Subject: Response to Request for Additional Information Regarding Dresden
Nuclear Power Station Unit 2 Exigent Amendment Request to Facility
Operating License DPR-19, Technical Specification Submittal for Dresden
Unit 2 Cycle 16
NRC Docket No. 50-237

RESPONSE TO RAI RE EXIGENT PROPOSED
CHANGE TO TECH SPECS

ATTACHMENT 1
REQUEST FOR ADDITIONAL INFORMATION
RESPONSE

Figure 3.1

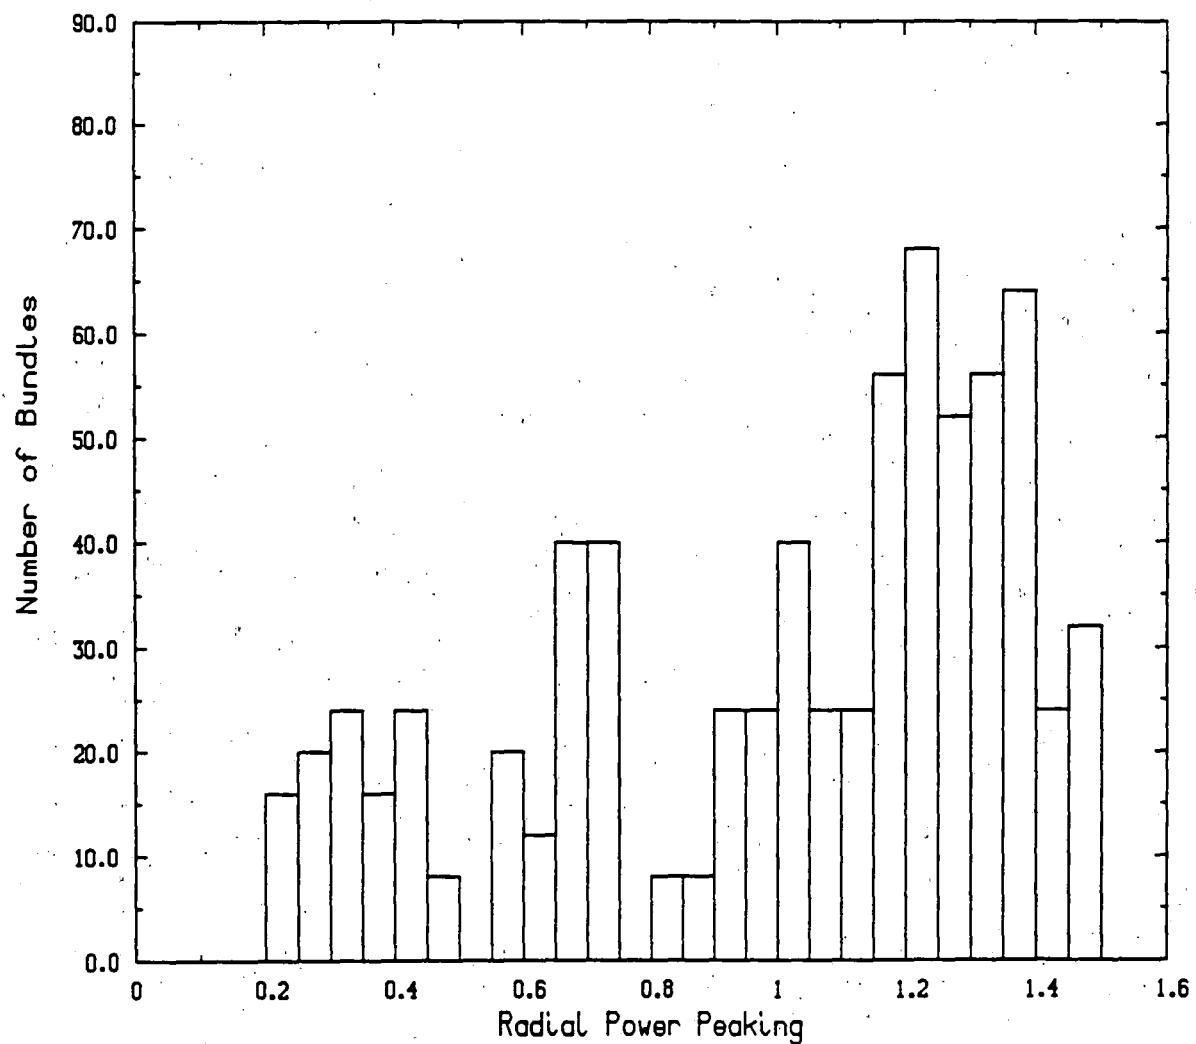
Provide the reload fuel types for both the Cycle 15 and Cycle 16 and identify their differences including the loading pattern, control blade patterns, actual bundle parameters (e.g., local peaking and radial power distribution), and the cycle exposure range?

Describe the calculational procedures for the analysis on the safety limit minimum critical power ratio including the approved methodologies and identify the impact from those differences on parameters given in the question #1.

- Enclosure I: Dresden Unit 2 Cycle 15 Radial Power Distribution Histogram Used as Input to the D2C15 MCPR Safety Limit Calculations
- Enclosure J: Dresden Unit 2 Cycle 16 Radial Power Distribution Histogram Used as Input to the D2C16 MCPR Safety Limit Calculations

Several differences between the Dresden Unit 2 cycle 15 and Cycle 16 fuel and core designs are identified in the response to Question 1. The cycle differences discussed in the response have the potential to affect the calculated safety limit and were explicitly included in the analyses for each cycle. The Technical Specification MCPR Safety Limit supported for Cycle 15 was 1.08 while a 1.09 limit is required for Cycle 16.
